Response to the Reviewers' Comments

The authors would like to thank the reviewers for the precious comments and suggestions on the technical contents and presentation of our manuscript "Runtime Power Management of Battery Electric Vehicles for Extended Range with Consideration of Driving Time," submitted to IEEE Transactions on Very Large Scale Integration (TVLSI.) This revised manuscript has been greatly improved thanks to the reviewers' invaluable advices. We have revised the manuscript faithfully following the reviewers's comments. We include the newly added or significantly modified parts in the revised version of the paper also in Response to Reviewers. We highlight the important technical content changes and set those parts in a red color in the revised paper.

Fig. 2: (a) Range-speed experimental data for Chevrolet Bolt [36] and (b) comparison with simulation results of the proposed EV power model.

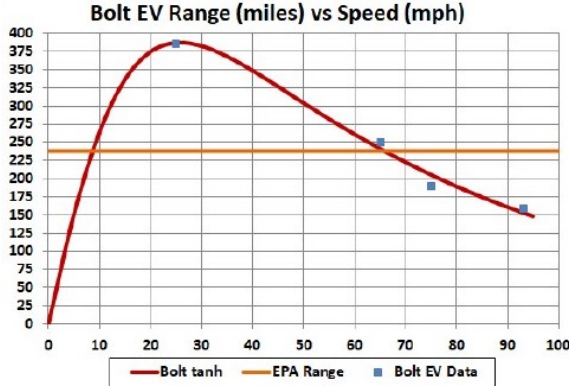
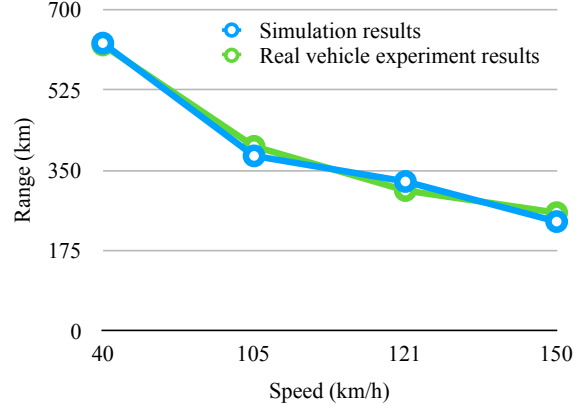
R1-C2 It is not clear how to validate the power model of EV. As the author mentions that accuracy of power model is quite important, it is good to see the power model in this paper can be validated by some real measurement results.

We further evaluate the model accuracy with the range-speed real vehicle experiments as shown in Fig. 2(a) to confirm the derived power models are close enough to the real vehicle measurement data [32], [33], [34], [35], [36]. We refine the coefficients until all the available data values match well.

As a result, the derived EV power model well matches with the range-speed experimental data as shown in Fig. 2(b) as well as the top speed and maximum acceleration setting the aerodynamic resistance, rolling resistance, curb weight, etc. with the known values. The errors in the range-speed simulation is merely 1.4%, the time for 0-to-100 km/h error is 7.8%, and the top speed error is 3.0%, respectively.

Fig. 12: Velocity profile comparison with EDP , E^2DP and E^3DP on Serrano Avenue in Anaheim Hills.

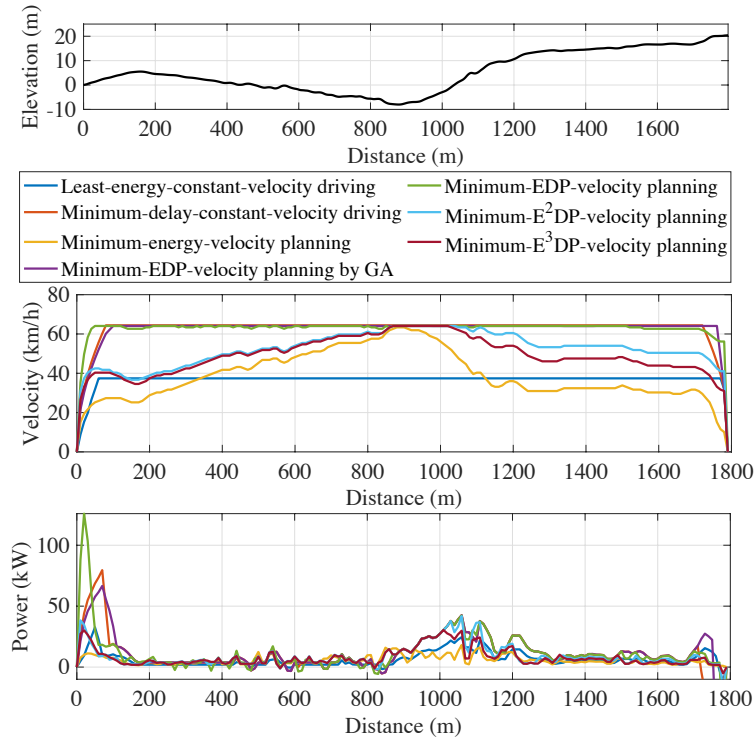
R1-C3 The optimality of the proposed scheduling algorithm is unclear. The author should add several paragraphs to discuss this topic. It is also to see the comparison baseline is well accepted to show the advantage of the proposed algorithm.

Fig. 12 summarizes EDP of the least-energy-constant-velocity driving, the minimum-delay-constant-velocity driving, the minimum-energy-velocity planning, the velocity planning with EDP , E^2DP and E^3DP as a metric on the road benchmarks and the minimum- EDP -velocity planning with GA. The proposed velocity planning results in up to 46.2% improvements of EDP compared with the least-energy-constant-velocity driving. The driving velocity on a flat road is faster than that of the least-energy-constant-velocity driving at the expense of relatively little energy to save driving time. Then, the velocity decreases when climbing the following uphill to spend less motor torque, which saves more energy.

In addition, EDP of the proposed EDP-aware-velocity planning is merely 4.3% higher than that of the true EDP-minimum-velocity planning on average. Through this results, we confirm that the results of the proposed heuristics are close enough to the true optimal solutions.

We also updated Fig. 12 and Fig. 13:

Fig. 11: Histograms of velocity and acceleration for the proposed energy-aware-velocity planning methods without an acceleration constraint (a) and (b) and with an acceleration constraint (c) and (d), respectively.

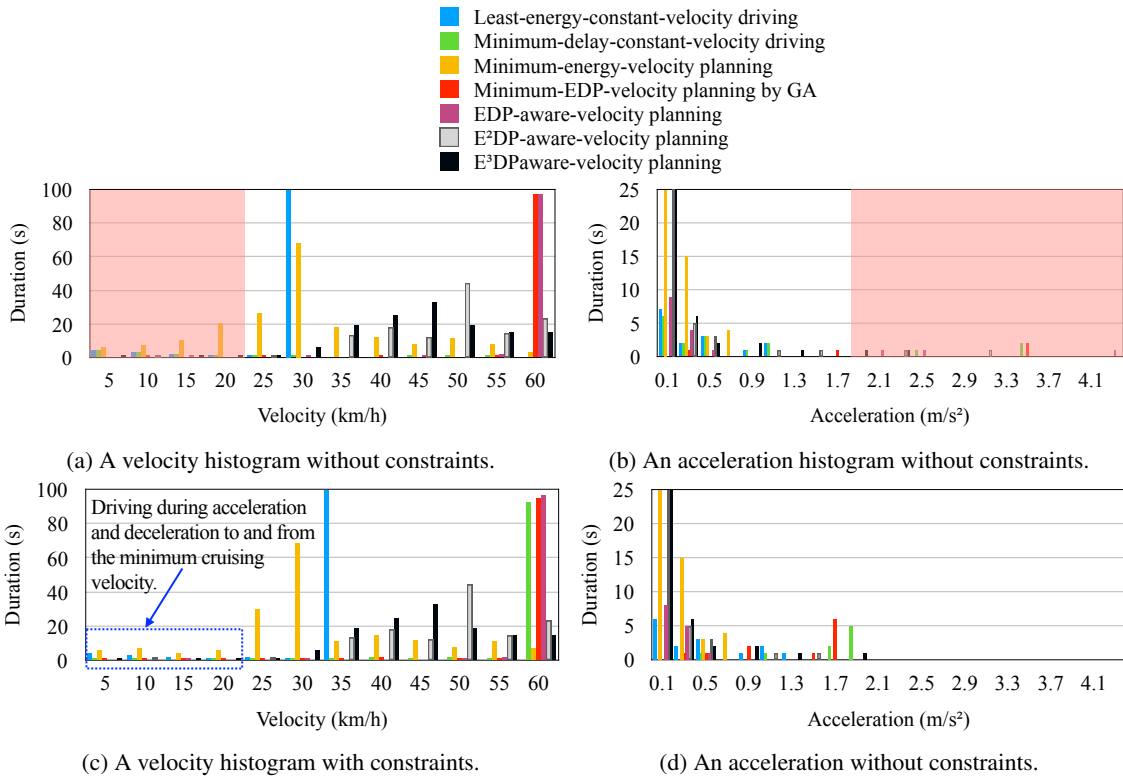
R2-C2 It would be good to have more discussion on the assumptions of the approach and the experiments, e.g., how much can the velocity be changed in practical scenarios without impeding traffic and causing unsafe situations (also depending on the road conditions and whether it is urban or rural environment I suppose). Currently, there only seems to be one constraint on not slower than 10 km/h.

Fig. 11(a) and (b) show two histograms of the driving schemes in Fig. 12, which do not have velocity and acceleration constraints. We avoid a cruising velocity lower than 25 km/h and an acceleration higher than 2.0 m/s^2 in this paper without loss of generality. The acceleration of 2.0 m/s^2 is the same as the maximum acceleration of compact cars designed to be used primarily used in urban areas (13 seconds of 0 to 100 km/h time).

Fig. 11(c) and (d) shows the velocity and acceleration histograms with the constraints. Once we run the DP for the first time without constraints, we analyze the histogram, adaptively determine the minimum cruising velocity and maximum acceleration constraints, and run DP again. We keep the same constraints for online recomputation whenever unexpected interrupts occurs.

Fig. 8: Altitude changes in the real road benchmarks.

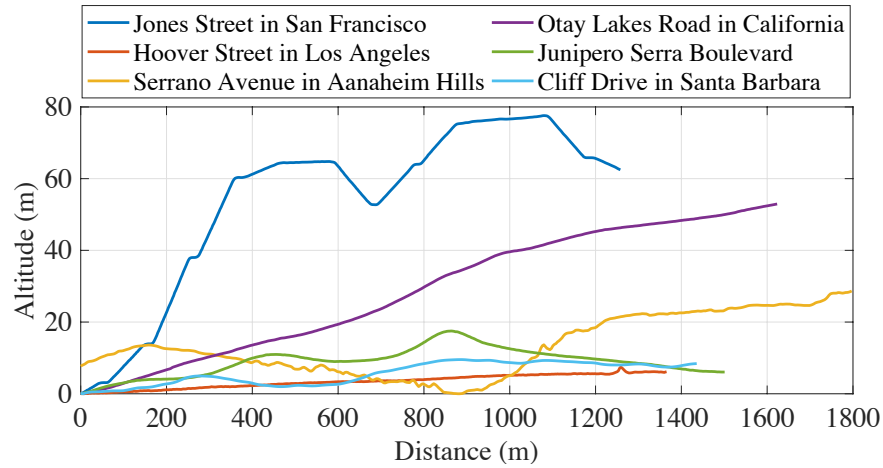
R2-C3 Related to the last point, it would be good to have more discussion on the road benchmarks, e.g., how they are generated and how representative they are. The optimization results significantly depend on road slope. It would be good to use a variety of real road segments for testing.

R2-A3 We appreciate the reviewer's comment. We replaced the previous synthetic road benchmarks with the real road benchmarks. We made six new real routes from various locations in California. The first three roads are in cities. Jones Street in San Francisco and Hoover Street in Los Angeles are two representative city landscapes such as hills and flat roads, respectively, and Cliff Drive in Santa Barbara is a mixture of those. The second two roads are in mountain areas: Serrano Avenue in Anaheim Hills and Otay Lakes Road in San Ysidro Mountain in California. The last road is Junipero Serra Boulevard connecting San Francisco and San Jose. The details of

road data is summarized in Table II, and Fig. 8, which visualize the altitudes of the road benchmarks. We also revised all the associated contents with the new real road benchmarks.
